# UNITED STATES PATENT AND TRADEMARK OFFICE

APPLICATION NO.	FILING DATE	FIRST NAMED INVENTOR	ATTORNEY DOCKET NO.	CONFIRMATION NO.
10/715,376	11/19/2003	Jonathan Zanhong Sun	YOR920030332US1	5483
21254	7590	08/17/2005	EXAMINER	
MCGINN & GIBB, PLLC 8321 OLD COURTHOUSE ROAD SUITE 200 VIENNA, VA 22182-3817			NGUYEN, THINH T	
			ART UNIT	PAPER NUMBER
			2818

**Office Action Summary**

### **DETAILED OFFICE ACTION**

**FIG. 1****FIG. 2****FIG. 3**

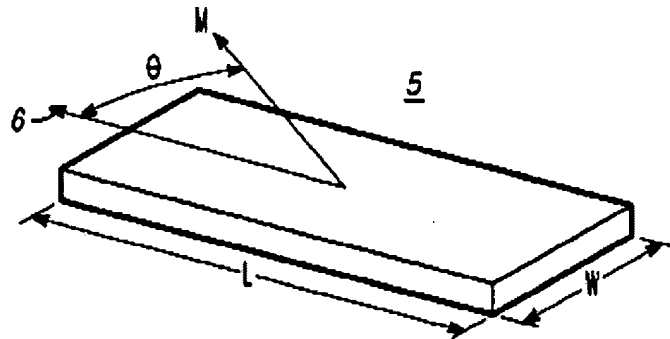
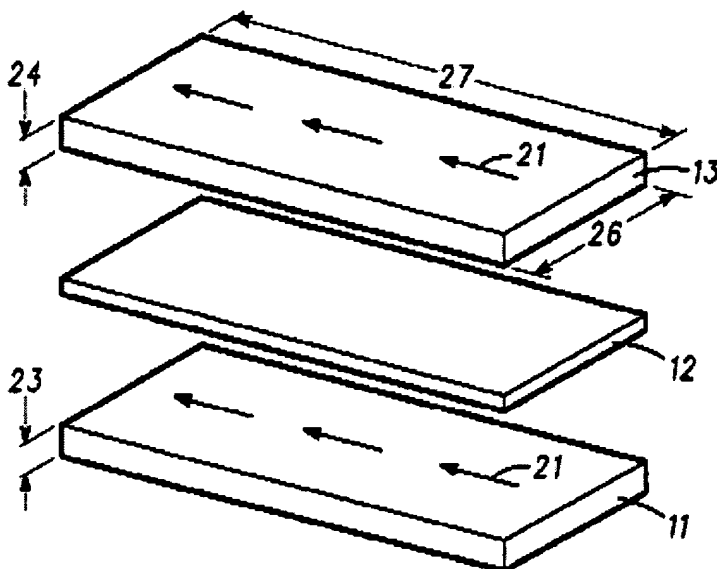
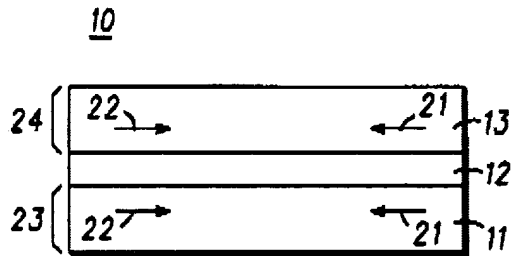
Chen ( fig 1,fig2,fig 3, column 2 lines 40-44,column 4 line 40) discloses a spin-current switched magnetic memory element, comprising: a plurality of magnetic layers, at least one of the plurality of magnetic layers ( fig 3 layer 11,13) having a perpendicular magnetic anisotropy

component and comprising a current-switchable magnetic moment; and at least one barrier layer( fig 3 layer 12) formed adjacent to the plurality of magnetic layers.

Chen discloses ( fig 3) a spin-switched magnetic element wherein the plurality of magnetic layers comprises an upper magnetic layer ( fig 3 layer 13 ) and a lower magnetic

layer ( fig 3 layer 11) , the at least one barrier layer ( fig 3 layer 12) being formed between the upper and lower magnetic layers.

FIG. 8

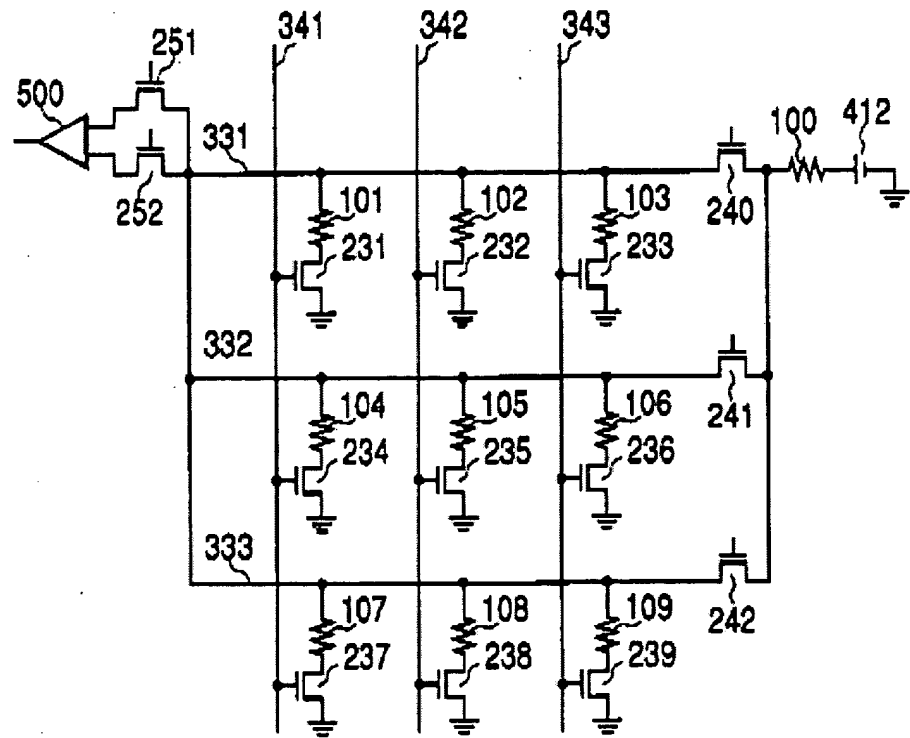
Ikeda ( Fig 8) discloses a memory array comprising of magnetic spin current switched magnetic elements

FIG. 9

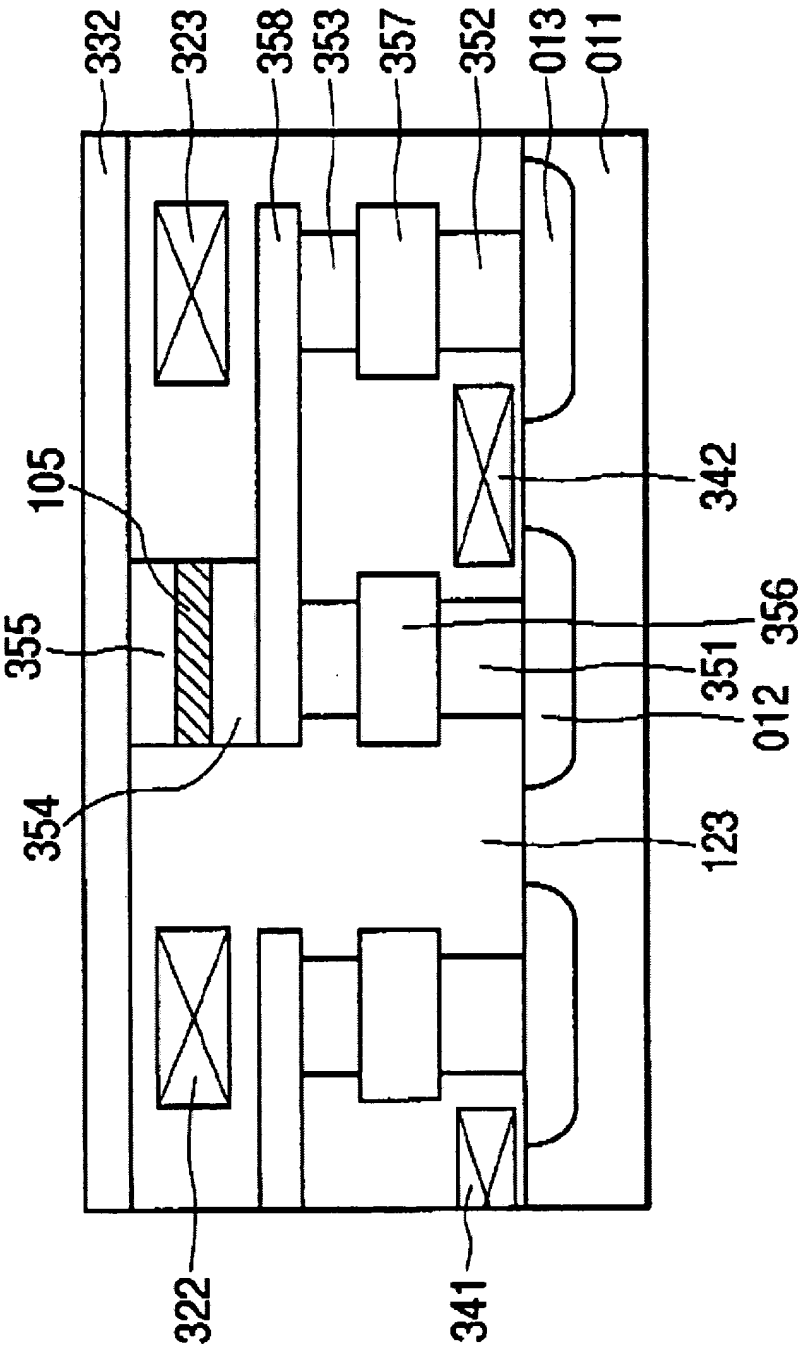
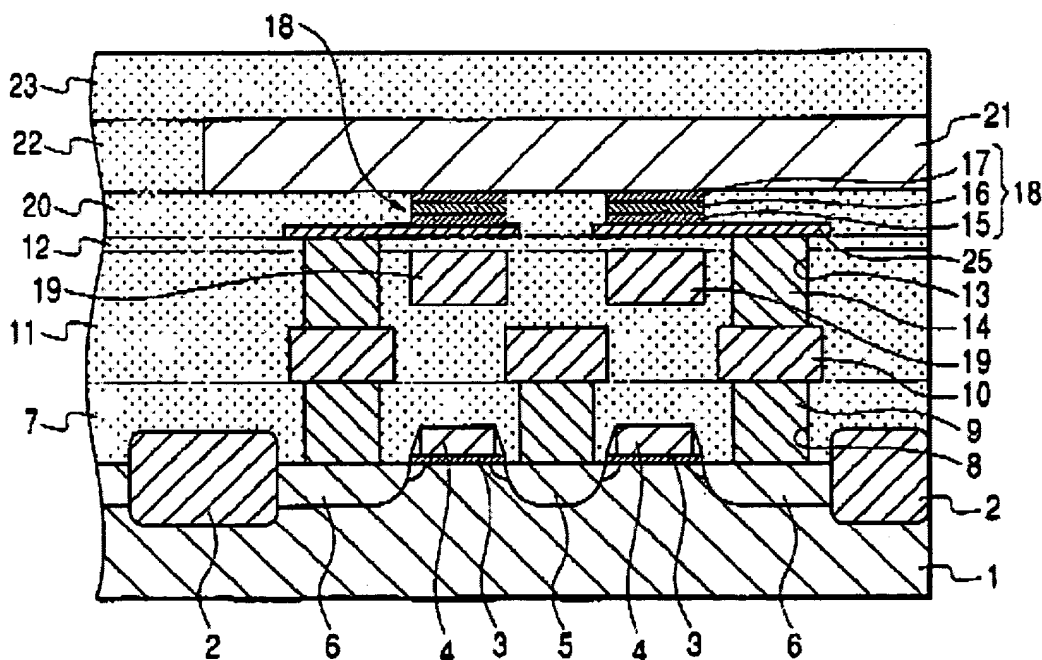
Ikeda ( in the abstract , in fig 9) discloses a spin-current switched magnetic memory element, comprising: a plurality of magnetic layers fig 9 layer 355,354), at least one of the plurality of magnetic layers having a perpendicular magnetic anisotropy component ( the abstract lines 3-4) and comprising a current-switchable magnetic moment; and at least one barrier layer ( fig 9 layer 105 ) formed adjacent to the plurality of magnetic layers and wherein said plurality of magnetic layers comprises at least one composite layer ( the abstract lines 5-7) . Noted that Ikeda discloses a tunneling magnetoresistive device ( column 7 lines 5-6 ) therefore it is inherently a spin switched magnetic memory device.

Ikeda ( in the abstract , in fig 9) discloses a spin-current switched magnetic memory element comprising: first and second leads ( fig 9 layer 332 layer 358 ) ; and a pillar formed between said first and second leads, said pillar including said at least one barrier layer (fig 9 layer 105) and at least one magnetic layer ( fig 9 layer 354 or 355 ) of said plurality of magnetic layers.

Ikeda ( in the abstract , in fig 9) discloses a spin-current switched magnetic memory element, comprising: first and second leads ( fig 9 layer 332 and 358) ; formed between the first and second leads, a plurality of magnetic layers( fig 9 layers 355,354) , at least one of the plurality of magnetic layers having a perpendicular magnetic anisotropy component ( the abstract ) and comprising a current-switchable magnetic moment; wherein one barrier layer comprise a tunneling barrier ( column 7 line s 5-6 ) and comprises Aluminum Oxide ( column 7 lines 5-10) .

Ikeda ( in the abstract , in fig 9) discloses a spin-current switched magnetic memory element, comprising: first and second leads ( fig 9 layer 332 and 358) ; formed between the first and second leads, a plurality of magnetic layers( fig 9 layers 355,354) , at least one of the plurality of magnetic layers having a perpendicular magnetic anisotropy component ( the abstract ) and comprising a current-switchable magnetic moment; and at least one barrier layer ( fig 9 layer 105) formed in the pillar adjacent to the plurality of magnetic layers. Noted that Ikeda discloses a tunneling magnetoresistive device ( column 7 lines 5-6 ) therefore it is inherently a spin switched magnetic memory device.

**FIG. 1B**

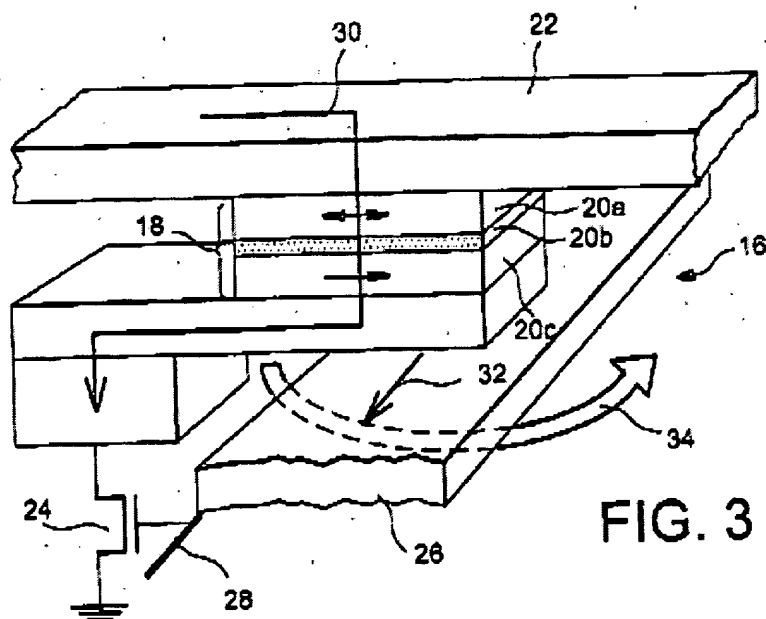
Hirai ( the abstract, fig 1B) discloses a spin-current switched magnetic memory element, ( fig 1B element 18) comprising: a plurality of magnetic layers( fig 1B layer 15,17), at least one of said plurality of magnetic layers having a perpendicular magnetic anisotropy component ( the abstract, lines 5-6) and comprising a current-switchable magnetic moment; and at least one barrier layer ( fig 1B layer 16) formed adjacent to said plurality of magnetic layers.

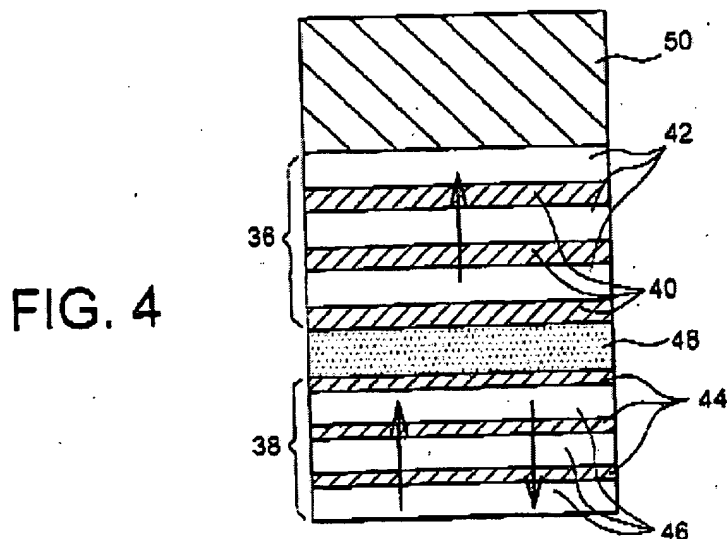
Dieny et al. ( fig. 3, paragraph [0118], paragraph [0122] ) discloses a spin-current switched magnetic memory element wherein the at least one composite layer comprises a platinum layer and a cobalt layer.

Dieny et al. ( fig. 3, fig 4, paragraph [0118], paragraph [0125] ) discloses a spin-current switched magnetic memory element wherein the at least one composite layer comprises a Nickel ( Ni ) layer and a copper (Cu) layer.

Dieny et al. ( fig. 3, fig 4 , paragraph [0118], paragraph [0122] ) discloses a spin-current switched magnetic memory element wherein said upper magnetic layer comprises one of a platinum layer formed on a cobalt layer.

Dieny et al. ( fig. 3, fig 4, paragraph [0118], paragraph [0122] ) discloses a spin-current switched magnetic memory element wherein said lower magnetic layer comprises one of a platinum layer formed on a cobalt layer.
